STANDARD FIELD SERVICE BULLETIN

FSB Number	CHRAEFSB2016-12
Author	Tony Bryan
Date	02/25/2016
Subject	XT1585 Droid Turbo 2, XT1580 Moto X Force - Does Not Charge - USB Connection Issues
Model Affected	XT1585 Droid Turbo 2, XT1580 Moto X Force
Level Of Repairs	Level 3

Fig. 1 - VR502 Diode Location

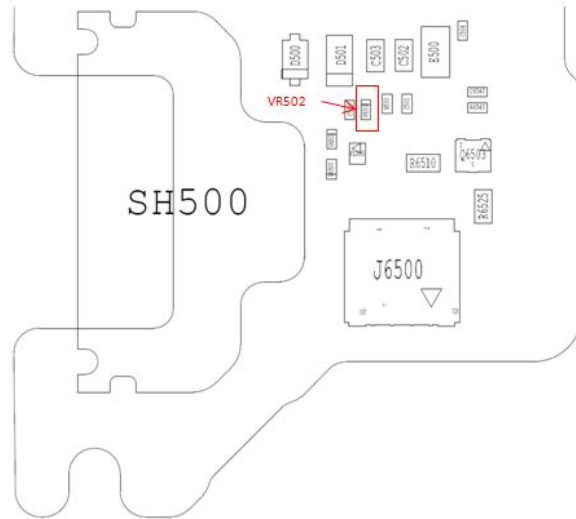
- Overvoltage Protection Diode VR502 (P/N: 48014187001) Damaged. Component is damaged from an undetermined over-voltage condition creating a low resistance on Pin #4 (EMU_ID) of the uUSB Connector. See Fig. 1 below.

- a. If one or more pins measure a higher than normal resistance, then the PCBA must be scrapped due to risk of solder pad delamination.
 - b. If Pin #4 (EMU_ID) of the uUSB Connector measures a lower than normal resistance, then replace Overvoltage Protection Diode VR502 (P/N: 48014187001).

Fig. 2a - External Contact Damage

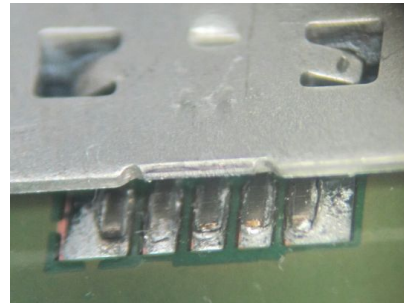
- uUSB Connector J500 (P/N: 09014162015W) Damaged. Connector has either damaged external contacts (Fig. 2a) or cracked solder joints on internal pins (Fig. 2b). The damage is due to excess mechanical force applied to connector from improper insertion/handling. See images below.

- Overvoltage Protection Diode Damaged - Motorola added new factory test procedures to screen for this issue - Completed February 22, 2016.
- uUSB Connector Damaged - Motorola added epoxy (Loctite EO1072) over the internal pins of the uUSB Connector to help strengthen the mechanical connection to the PCBA - Completed April 25, 2016

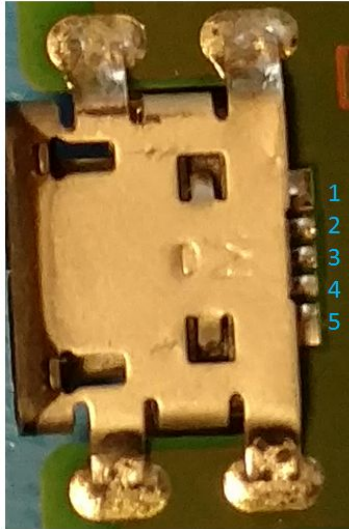
1. Confirm the customer complaint by testing “Charging” functionality using approved testing procedures.
2. Use a Digital Multimeter (DMM) to measure resistance from each of uUSB Connector pins to GND. See image below for details.

- c. If Pins #2, #3 (USB D+/D-) of the uUSB connector measure a low resistance short to GND, then replace the U1000 MSM8994 IC (Service P/N: 51016314001).
